**MARCH 20, 2018 ZONING HEARING
“OTHER BUSINESS”
COMMISSION DISTRICT 2**

ITEM OB-013

To consider a site plan and stipulation amendment for Bass Development Corp regarding rezoning application Z-14 of 2013 for property located at the southeastern intersection of Wesley Chapel Road and Chapel Heights Drive in Land Lots 256 and 321 of the 16th District (3902 Chapel Heights Drive).

ELEVATION CERTIFICATION
 FOR
 3902 CHAPEL HEIGHTS DR
 MARIETTA, GA 30062
 COBB COUNTY, GEORGIA
 LL 321, 16TH DIST., 2ND SECT.

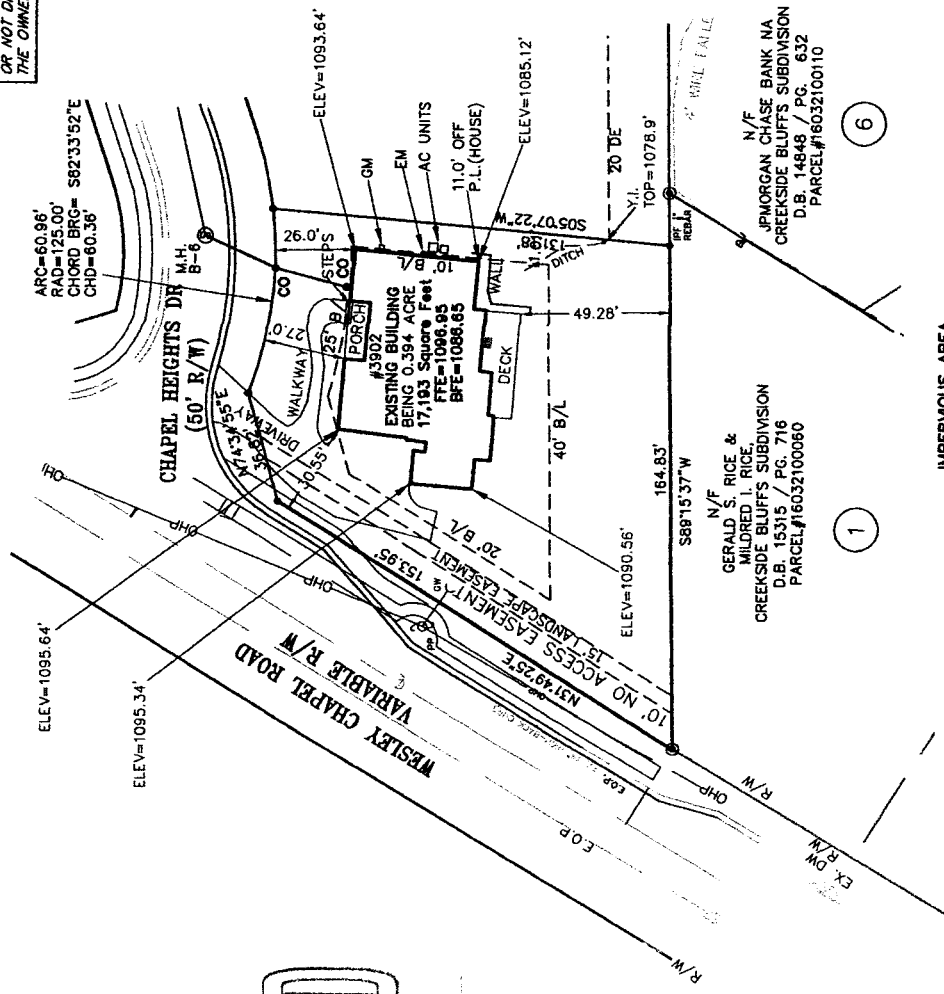
Cobb DOT: 1. Per Cobb County Development Standards, recommend driveway be relocated a minimum of 50' from the Wesley Chapel Road intersection; 2. Recommend a deceleration lane on Wesley Chapel Road for the entrance to the Chapel Heights Subdivision, as shown on the final subdivision plat; and 3. Recommend signage be located outside of the right-of-way and roadway easement. Recommend signage be located where it will not impede the line of sight for the driveways or roadways.
